FLOOR PLAN

IWA 2025
Venue: CTICC 1: Ballroom West & East
Show Dates: 16-20 March 2025

DWG NO: 4/rev11
2024-10-25

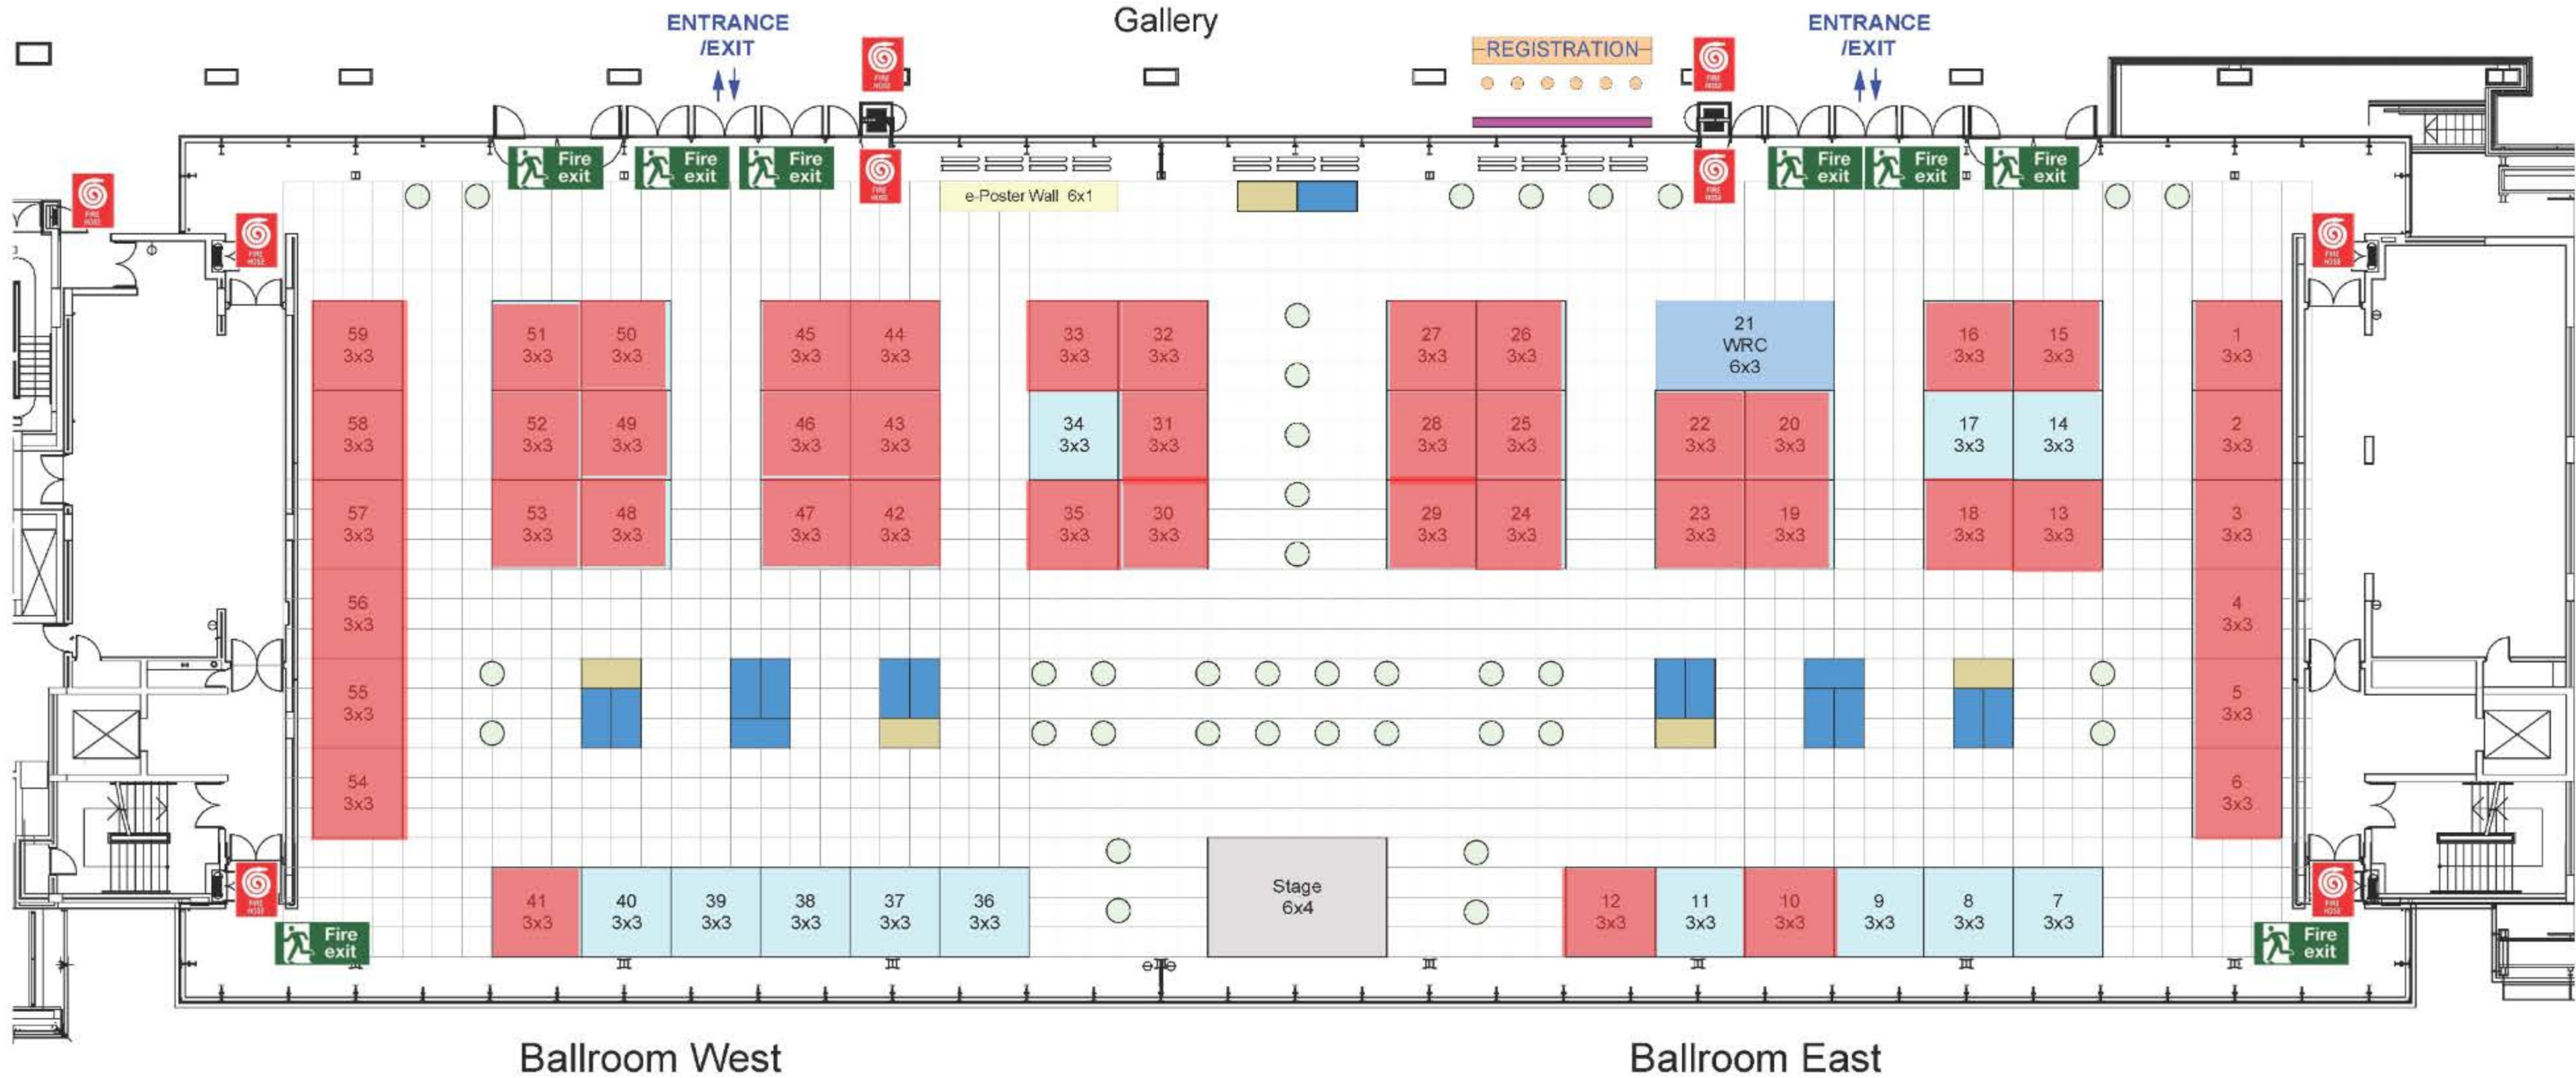
Reviewed by George Skazikis
08:06, 30 Oct 2024

THIS IS A FLOOR PLAN REVIEW ONLY
Stage/Structure schematics required
